RALPH G. MASTROMONACO, P.E., P.C.

Re: Wael Alesawy Subdivision – 32 Orchard Drive
Armonk, NY

We received comments from John Kellard, PE dated April 20, 2023 updated September 8, 2023, and we offer the following information:

We received a Staff Report from the Town of North Castle Planning Department dated August 9, 2023 for Meeting Date September 11, 2023, and we offer the following information:

LOT WIDTH CALCULATIONS
 PROPOSED SUBDIVISION
 AT
 32 ORCHARD DRIVE
 TOWN OF NORTH CASTLE
 WESTCHESTER COUNTY, NY
 SEPTEMBER 20, 2023

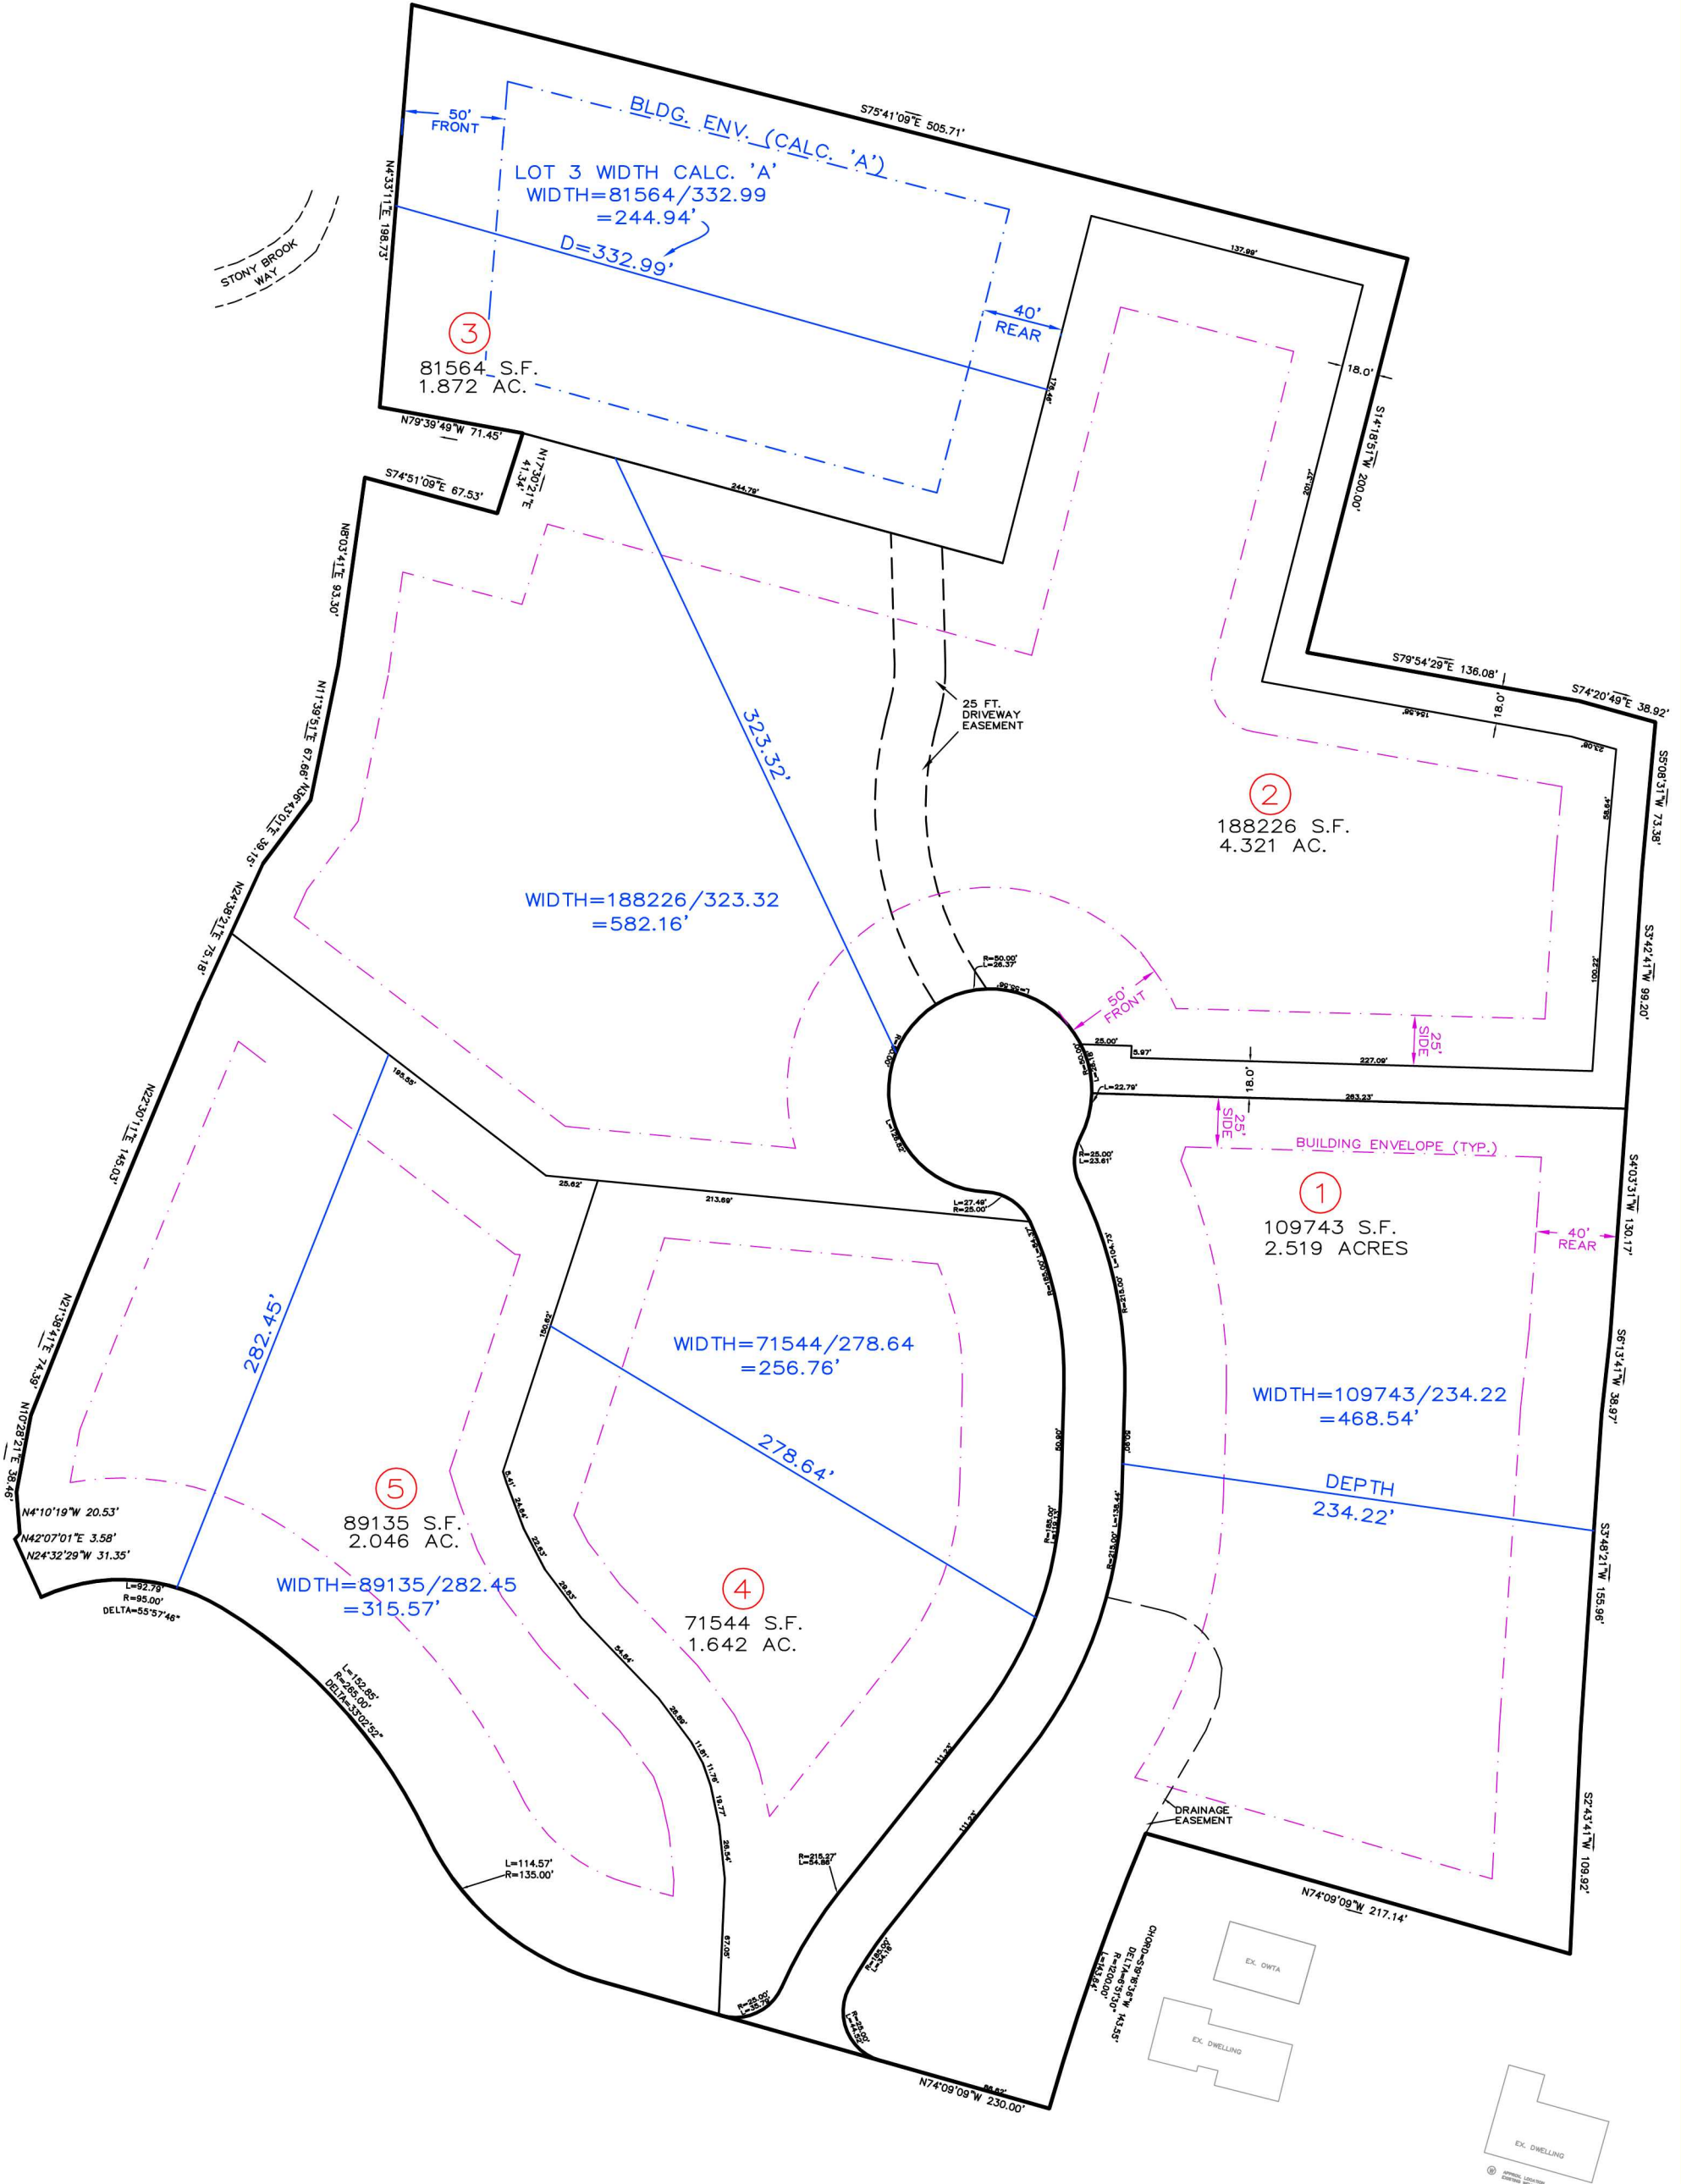
An exhibit demonstrating how average lot width and lot depths were calculated for the 5 lot subdivision plan should be submitted for review.

Response: These dimensions have been checked by our office and we have provided an exhibit that explains the computations.

CALCULATION 'A'
 LOT WIDTH CALCULATIONS
 (ALTERNATE LAYOUT)
 PROPOSED SUBDIVISION
 AT
 32 ORCHARD DRIVE
 TOWN OF NORTH CASTLE
 WESTCHESTER COUNTY, NY
 SEPTEMBER 20, 2023

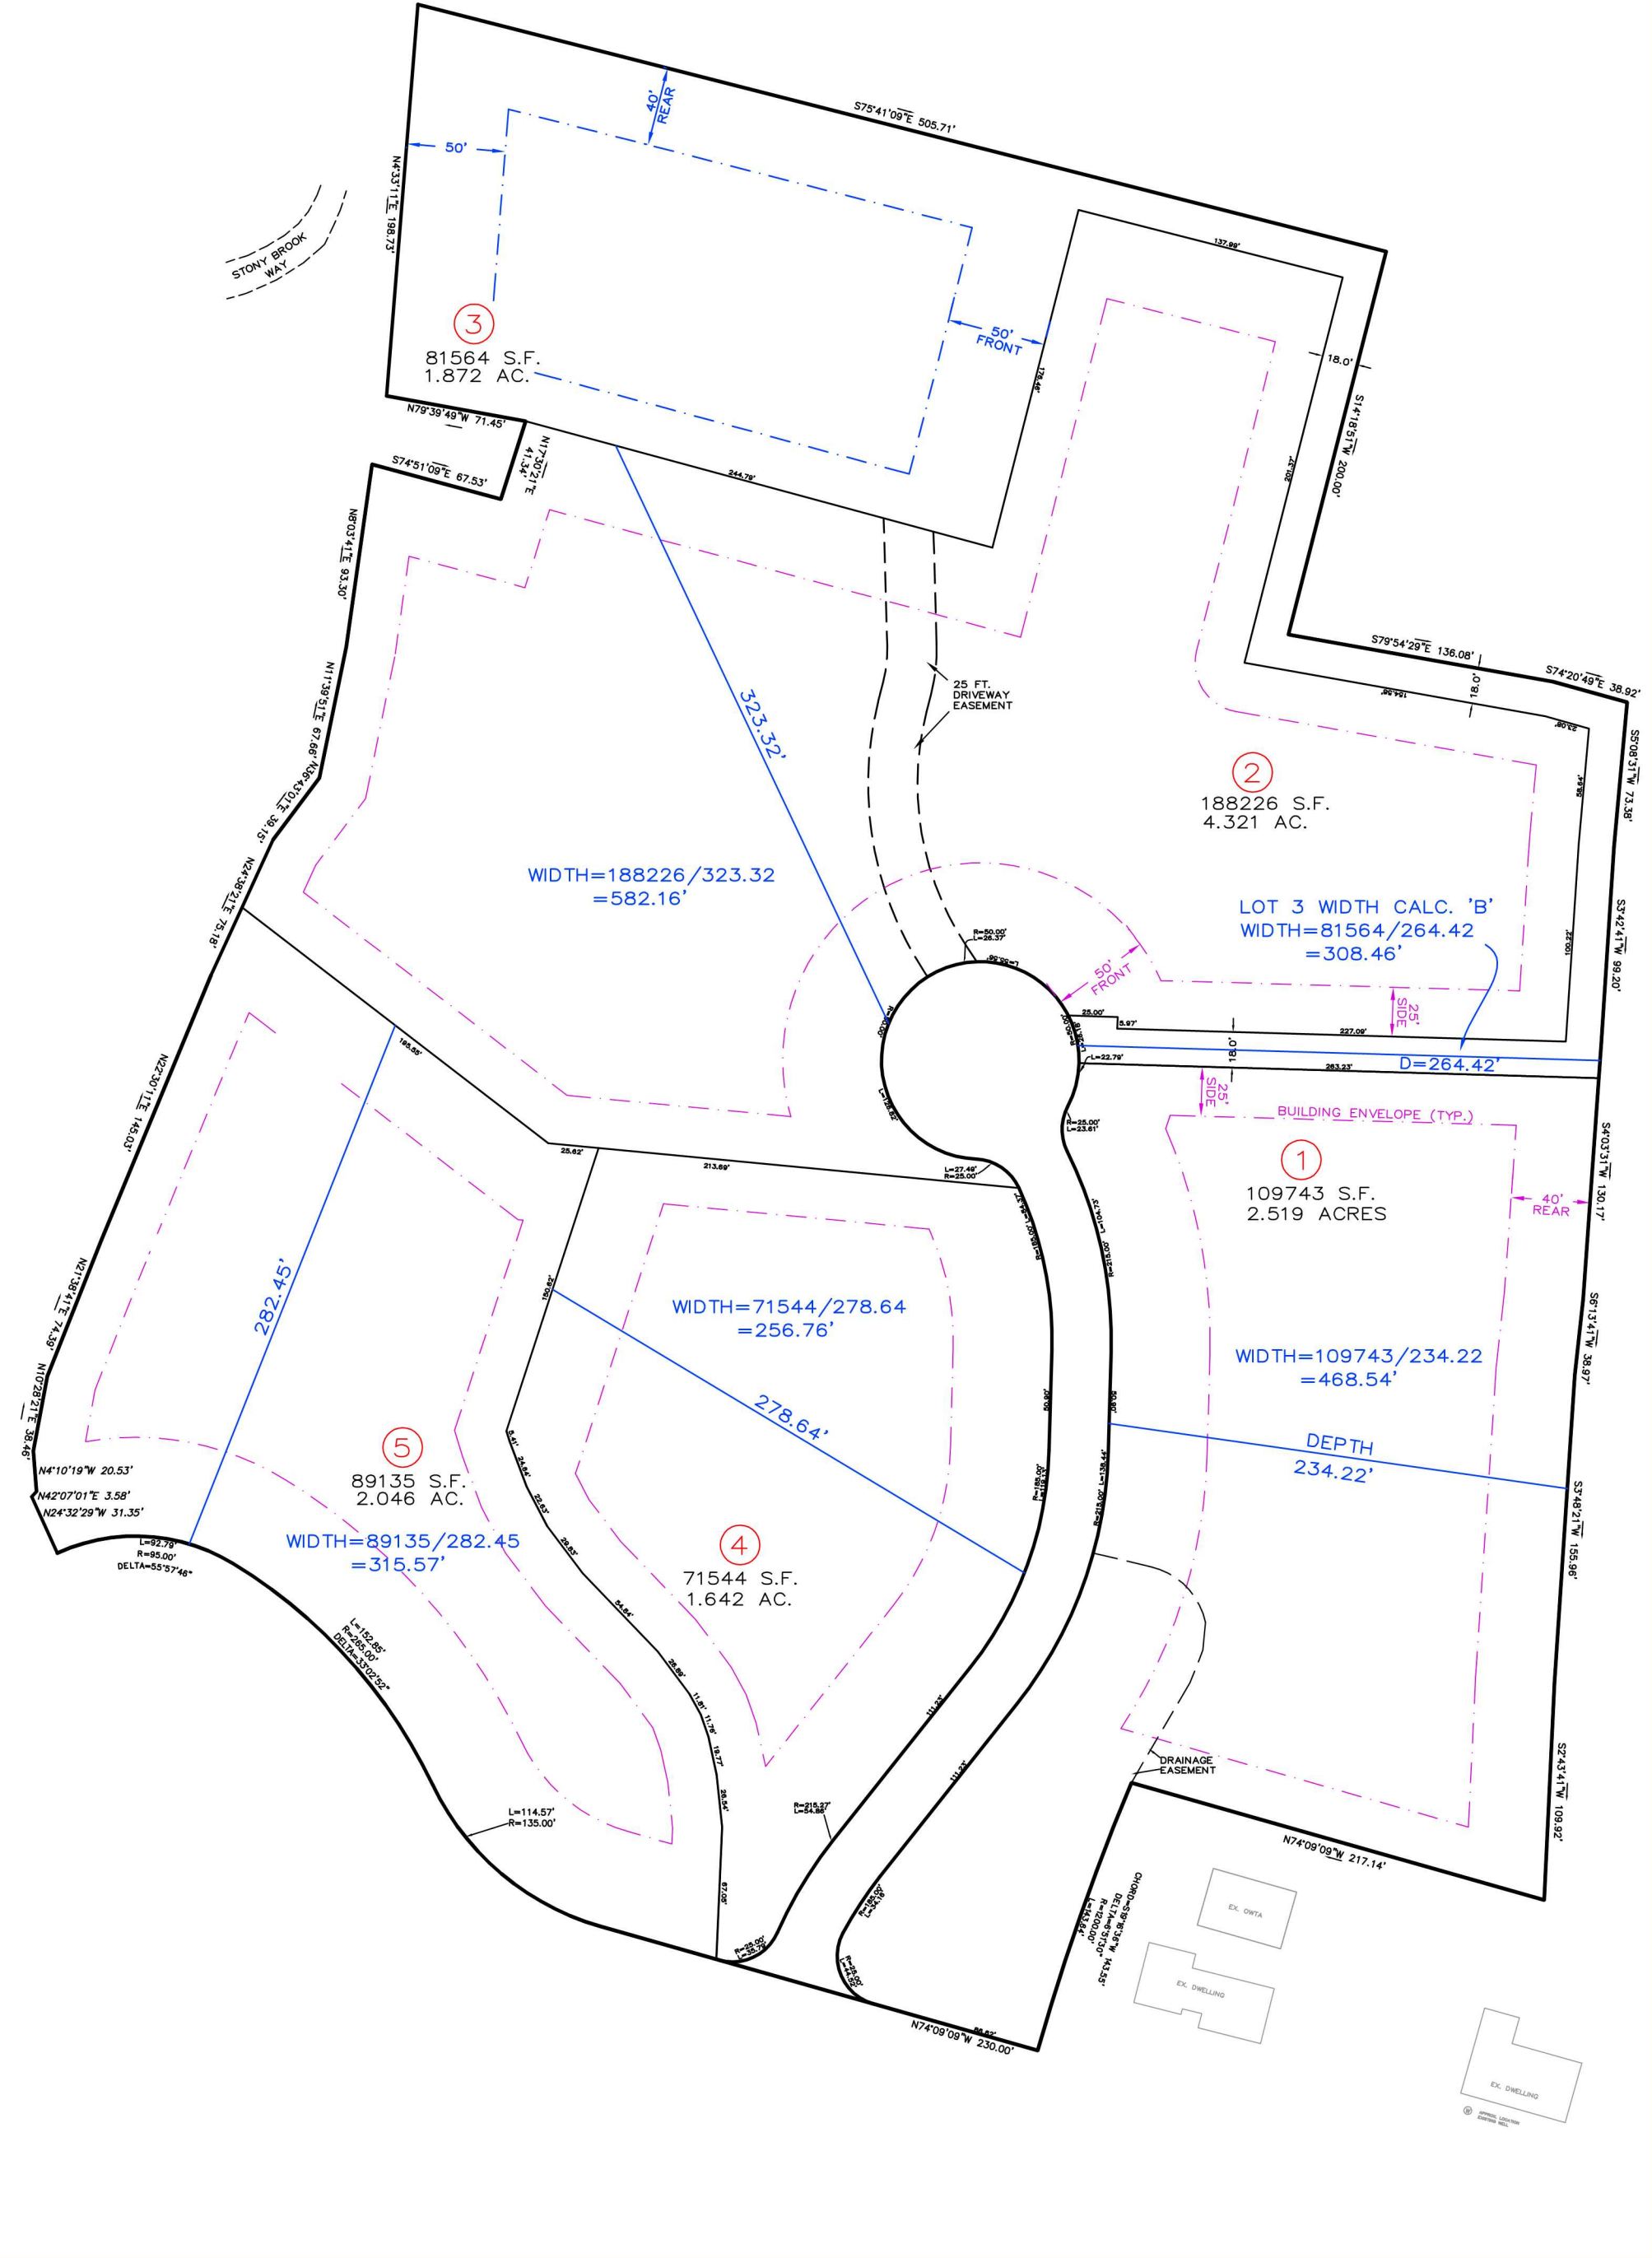
(Comment cont'd) The Alternate Plan provides an irregular shaped access strip for Lot #3, which is 15 feet wide and 900+ feet long around Lot #2 in an effort to establish frontage on the private roadway. The lot is not accessible through this access strip. Furthermore, when evaluating conformance to the Bulk Zoning Requirements for the District, a lot with a total depth of 1,200+ feet would need to be at least 150,000 s.f. (3.44 acres) in size to conform to the width requirements (125 feet) of the District. The applicant should reevaluate zoning compliance of Lot #3.

Further, since the Town defines frontage from a “Way”, our median line could be drawn from Stony Brook “Way” to the rear property line and still be conforming as to average lot width. All of these computations of Average Lot Width are provided on the attached exhibit.
